Access Compliance Report

Public Rights-of-Way

(Curb Ramps)

Intersection ID: 10019149	Main Street: ATKINS_RIDGE_DR	Cross Street: N/A	Location: N
ADA ID: 956BE85F98DE	Ramp Type: Perp	Initial Pass/Fail: Fail	Overall Compliance: No
			Severity Score: 8.75
Codes/Mitigation Info/Possible Solution		Field Measurements/Component Compliance

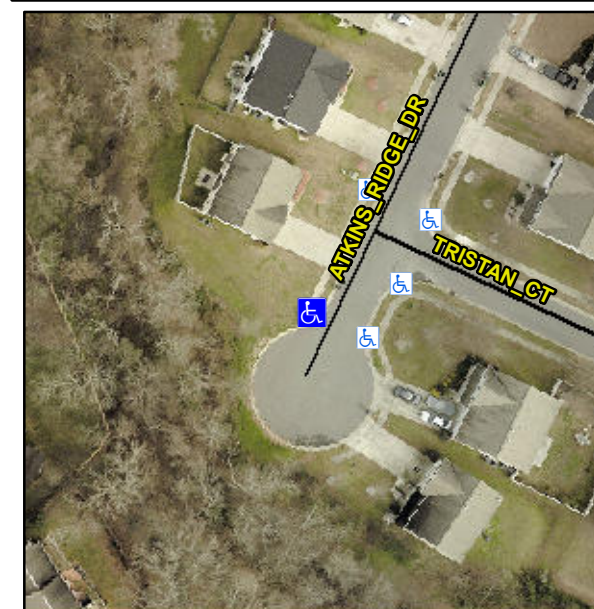
Not Found, R304.5.1

Compliance	Description	Data	Compliance	Description	Data
N/A	Ramp Length (in)	47.0	Yes	Ramp Slope (%)	5.6
No	Ramp Width (in)	47.0	Yes	Ramp XSlope (%)	0.7
N/A	Flare Type LT	N/A	N/A	Flare Type RT	N/A
N/A	Flare Slope LT (%)	N/A	N/A	Flare Slope RT (%)	N/A
N/A	Flare Traversable LT?	N/A	N/A	Flare Traversable RT?	N/A
N/A	Landing Length (in)	N/A	N/A	DWS Provided?	N/A
N/A	Landing Width (in)	N/A	N/A	DWS Contrast?	N/A
N/A	Landing Slope (%)	N/A	N/A	DWS Length (in)	N/A
N/A	Landing X Slope (%)	N/A	N/A	DWS Full Width?	N/A
N/A	Landing Curb? (Y/N)	N/A	N/A	DWS Offset (in)	N/A
N/A	Shared Landing?	N/A			
N/A	Gutter Ponding?	N/A	N/A	Gutter Slope (%)	N/A
N/A	Gutter Lip Ht (in)	N/A	N/A	Gutter X Slope (%)	N/A
N/A	Painted X Walk1?	No	N/A	Painted X Walk2?	N/A
	X Walk 1 Direction	To SE		X Walk 2 Direction	N/A
N/A	X Walk 1 Width (in)	N/A	N/A	X Walk 2 Width (in)	N/A
	X Walk 1 Slope (%)	6.3		X Walk 2 Slope (%)	N/A
	X Walk 1 X Slope (%)	2.5		X Walk 2 X Slope (%)	N/A

Remove & Replace Entire Ramp.
